Access Compliance Report

Public Rights-of-Way

Intersection ID: 51371	Main Street: UNIVERSITY_POINTE_BV	Cross Street: N_TRYON_ST	Location:	N
ADA ID: FB4AF6923D29	Ramp Type: BlendTrans2	Initial Pass/Fail: Pass	Overall Compliance: No	Severity Score: 5

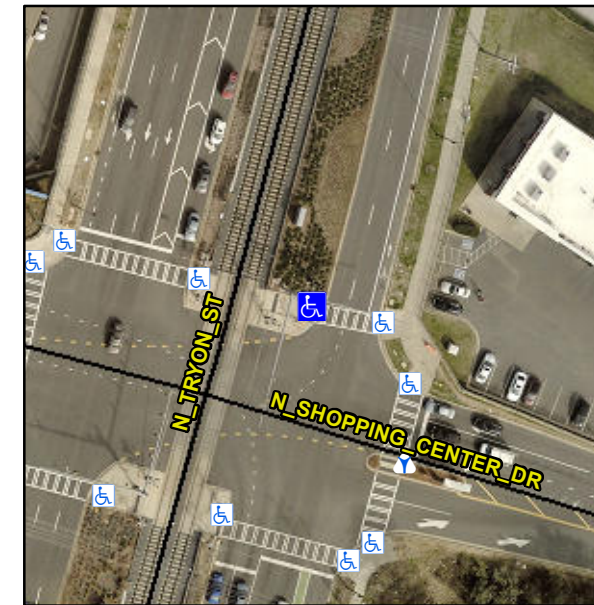
R304.2.3, R305.2

Compliance	Description	Data	Compliance	Description	Data
N/A	Ramp Length (in)	85.0	Yes	BlendTrans Slope (%)	2.5
Yes	Ramp Width (in)	120.0	Yes	BlendTrans XSlope (%)	0.9
No	Flare Type	Curbed_WithWalkSurface	Yes	Flare Type	Curbed_NoWalkSurface
N/A	Flare Slope LT (%)	N/A	N/A	Flare Slope RT (%)	N/A
N/A	Flare Traversable LT?	No	N/A	Flare Traversable RT?	No
N/A	Landing Length (in)	N/A	Yes	DWS Provided?	Yes
N/A	Landing Width (in)	N/A	Yes	DWS Contrast?	Yes
N/A	Landing Slope (%)	N/A	Yes	DWS Length (in)	24.5
N/A	Landing X Slope (%)	N/A	Yes	DWS Full Width?	Yes
N/A	Landing Curb? (Y/N)	No	No	DWS Offset (in)	3.0
N/A	Shared Landing?	No			
Yes	Gutter Ponding?	No	Yes	Gutter Slope (%)	3.8
Yes	Gutter Lip Ht (in)	0.0	Yes	Gutter X Slope (%)	1.5
N/A	Painted X Walk1?	No	N/A	Painted X Walk2?	N/A
	X Walk 1 Direction	To E		X Walk 2 Direction	N/A
	X Walk 1 Width (in)	N/A		X Walk 2 Width (in)	N/A
	X Walk 1 Slope (%)	2.5		X Walk 2 Slope (%)	N/A

Remove & Replace Curb Ramp With Two New Directional Ramps or Equivalent.
